**MORNINGTON PENINSULA RATEPAYERS' AND RESIDENTS'
ASSOCIATION INC.**

Submission: Draft Jetty Road Foreshore Recreation Node Master Plan

The Mornington Peninsula Ratepayers' and Residents' Association Inc. provides the following comment on the Draft Jetty Road Foreshore Recreation Master Plan (Draft Plan).

Figure 2. Narrow laneway effect of Amendment C175

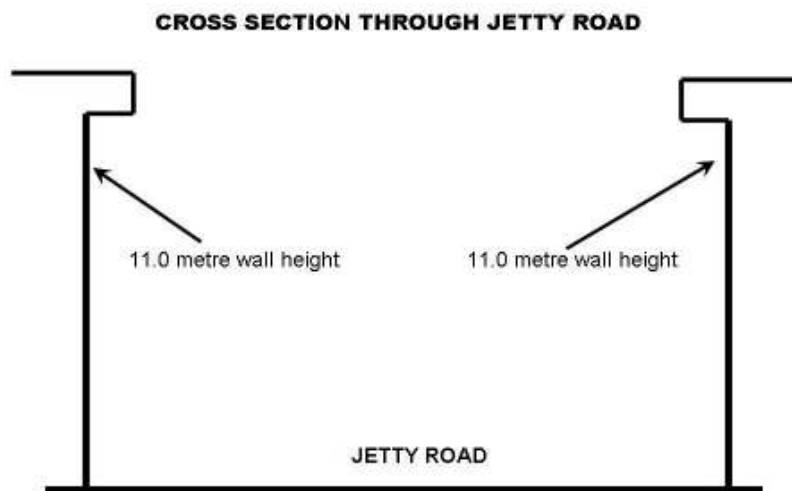
There appears to have been little, if any, consideration by the Shire planners with Amendment C175 and the authors of the Draft Report of the need to open up Jetty Road to facilitate awareness of the pier and foreshore.

"From the elevated southern side of the Jetty Road/Point Nepean Road intersection there is a linear view of the bay and pier. However from the northern side of this intersection the view is obscured by cars parked at the Jetty Road car park."

However the Draft Plan ignores the future development of Jetty Road as provided by Amendment C175, the result of which will in effect give Jetty Road a narrow laneway appearance rather than opening up the view to the pier and foreshore. This will restrict visitor awareness and appreciation from Point Nepean Road (see Figure 2 below).
